**Planning and Zoning Commission
January 6, 2022
Council Chambers
6:00 PM**

Subject: Petition No. 2021 -01 (ALU) CDP Amendment - Maitland Concourse North (MCN)
Requested Action or Motion: After receiving public comments, forward the proposed CDP Amendment, Petition No. 2021-01 (ALU), to remove the prohibition of drive-thru uses on Lot 1, MCN to Council with a recommendation of approval.
Summary Explanation & Background: The Maitland Concourse North (MCN) CDP Amendment was adopted in 2013 via Ordinance 1236. This established a Policy and Standards to guide the MCN mixed use development program on the roughly 96 gross acre site on the north side of Maitland Boulevard. The CDP standards were designed to regulate items such as appearance (residential scale and character); buffering, size (no big box); floor area ratio, height, and uses (including use prohibitions). Among the uses prohibited within the (R-MORC) commercial portion of the site were, <i>drive-through establishments of any kind</i>. The R-MORC commercial portion of the site covered Lots 1,2,3,6 and a portion of Lots 4 (stormwater pond) and 7 (developed with 350 multi-family units) . The CDP amendment proposes to remove the

SP.01

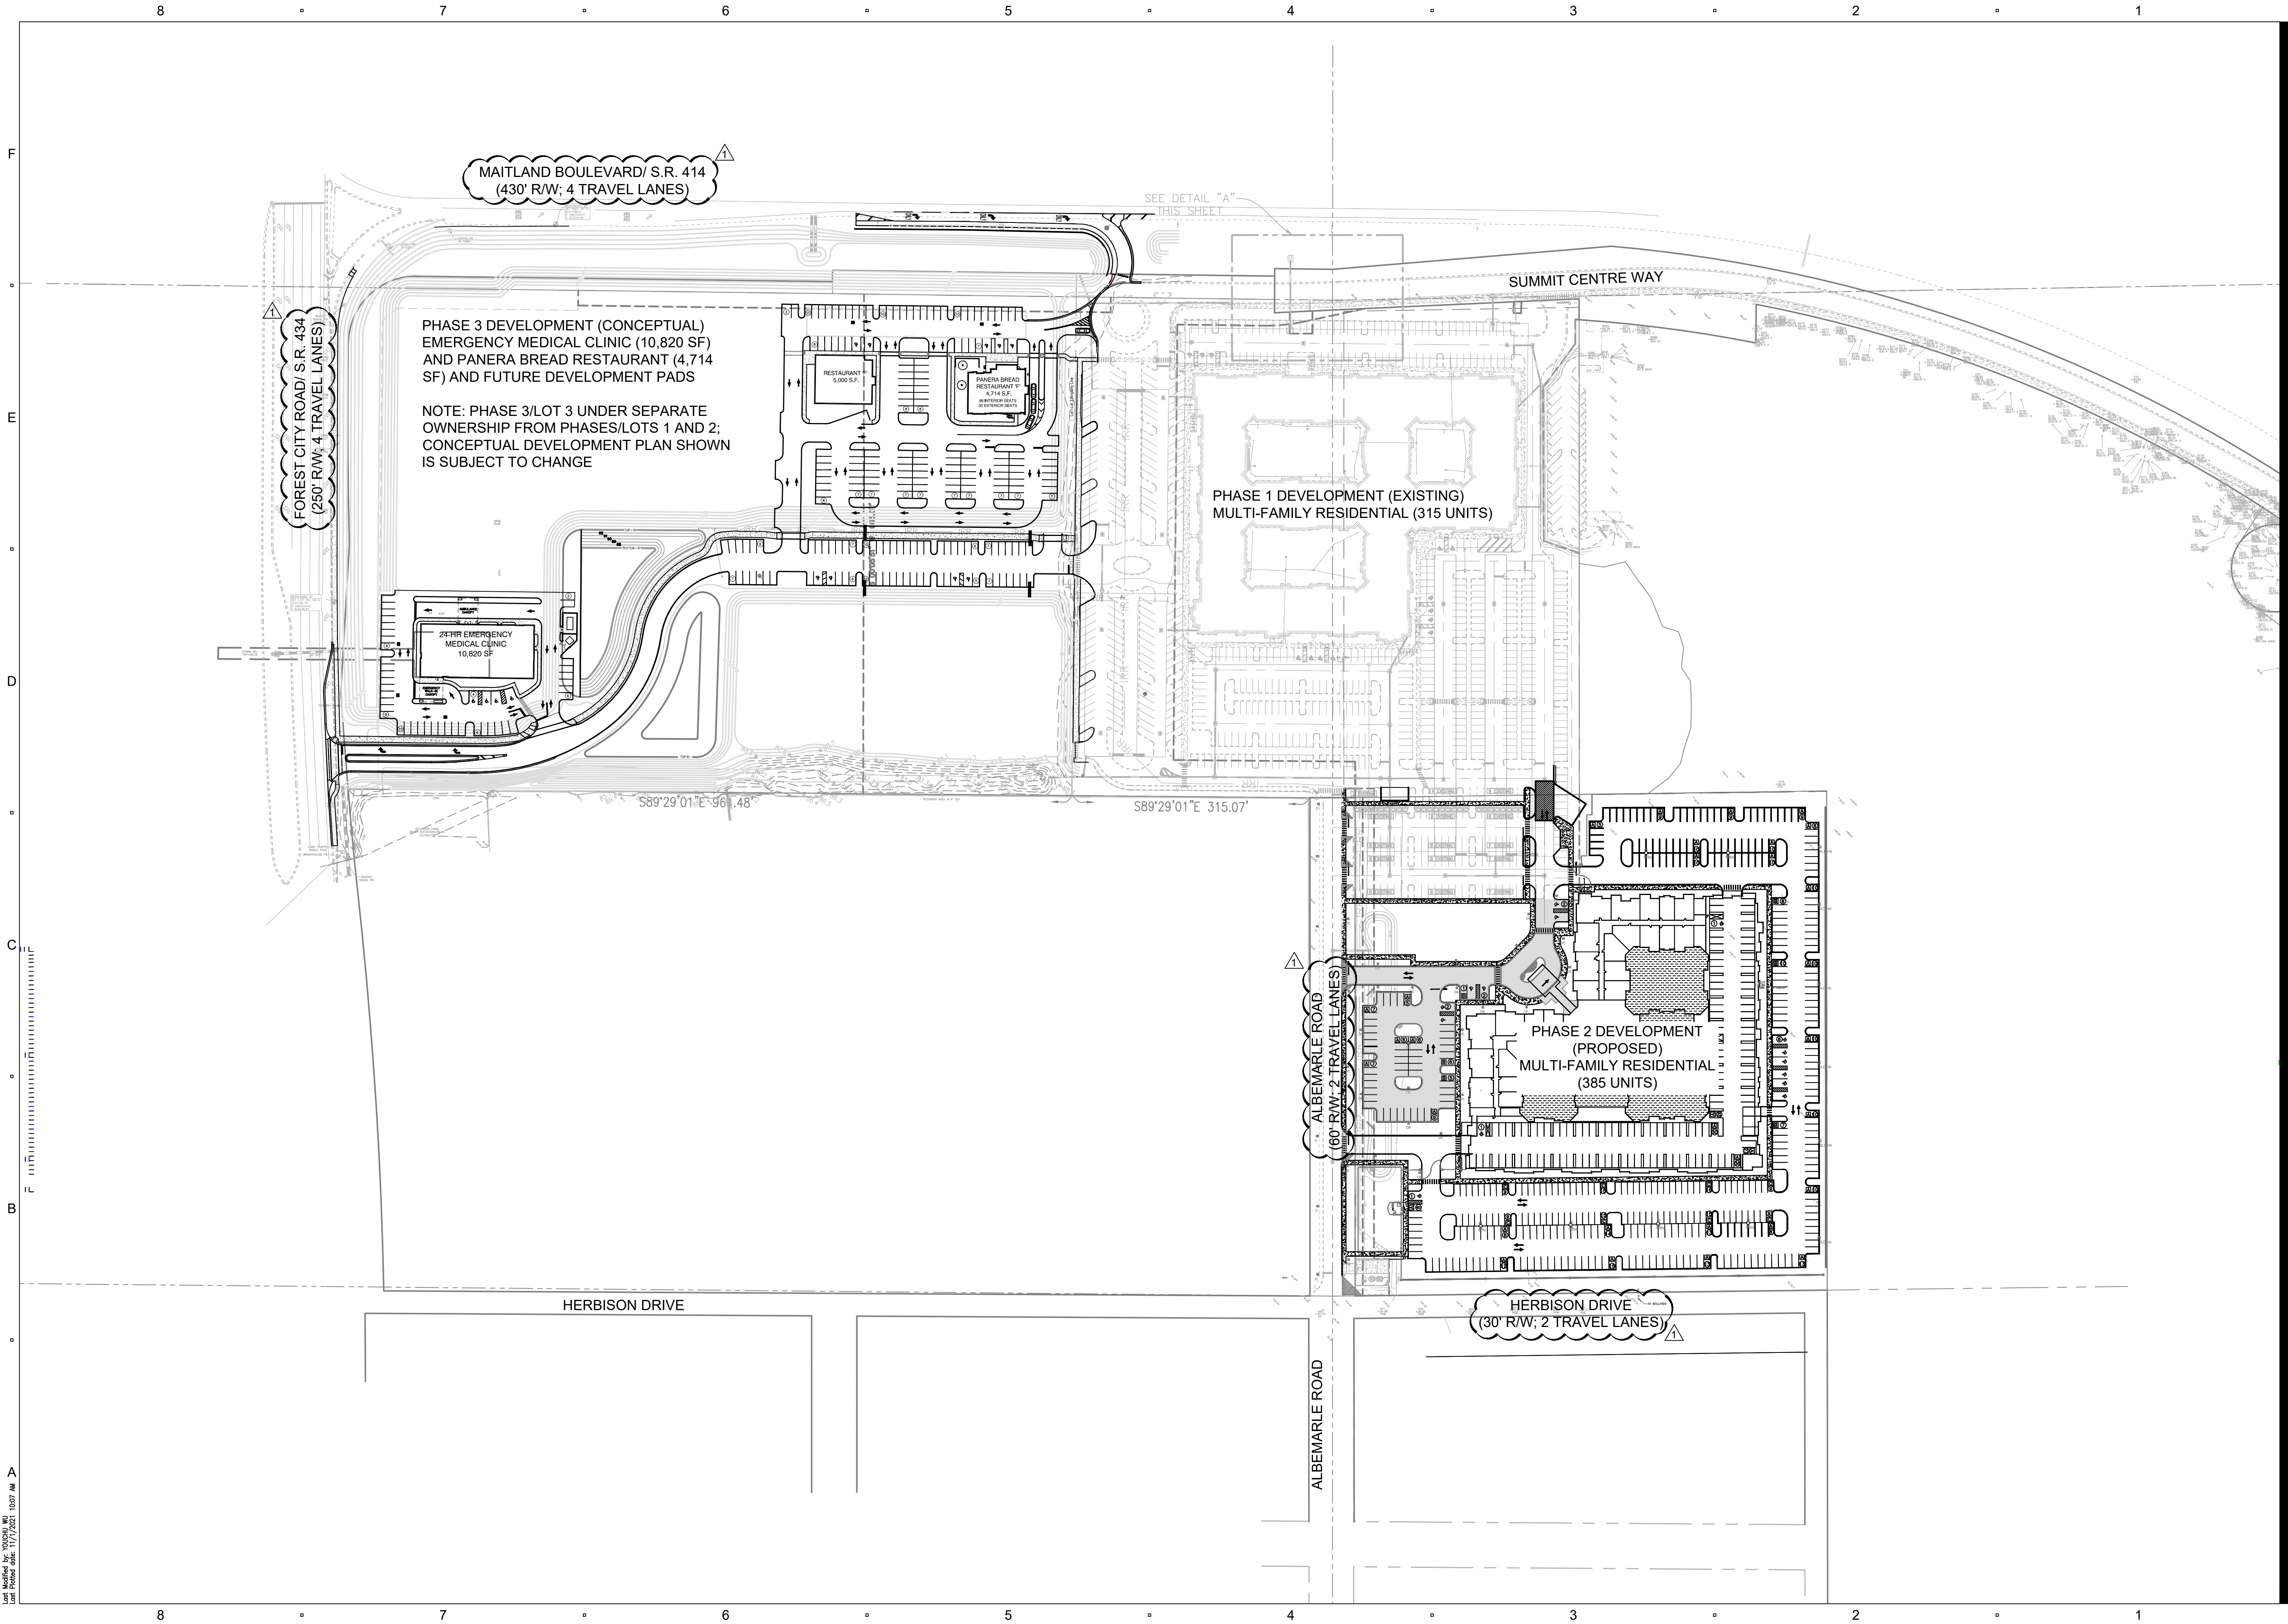
1. The proposed 20' Propriety Public Easement was added to the plan sheet SP.01 Site Plan. The easement must be provided prior to Site Permit Close-Out.
